SERVICE INFORMATION SHEET 218

SI 218 - May, 2022

Cheetah II (SCZII) Steering Control Lever Interference

Figure 1. Control Lever Interference

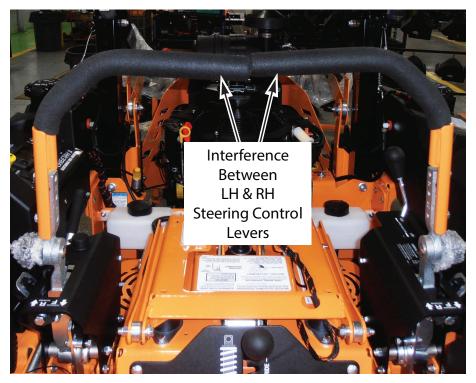
We have received reports from the field involving a limited number of Cheetah II (SCZII) machines experiencing interference between the LH & RH Steering control levers. See Figure 1 below.

This condition can be resolved by installation of spacer part number 431179 in the LH & RH pivot control weldments as described on Page 2.

Figure 2. Remove & Retain Hardware - RH Shown

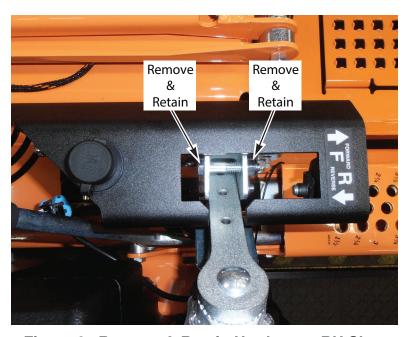
1.) Remove and retain the 5/16-18 x 1-3/4" hex head bolt and 5/16-18 elastic stop nut identified in Figure 2 below.

Figure 3. Install Spacer p/n 431179 - RH Shown

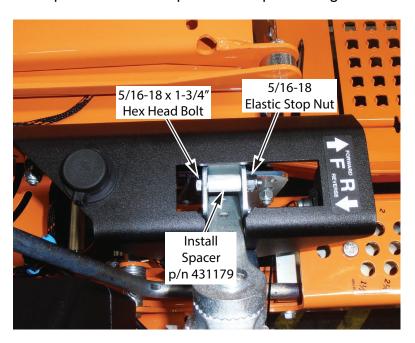
2.) Install spacer p/n 431179 and secure using 5/16-18 x 1-3/4" hex head bolt and 5/16-18 elastic stop nut removed in previous step. See Figure 3 below.
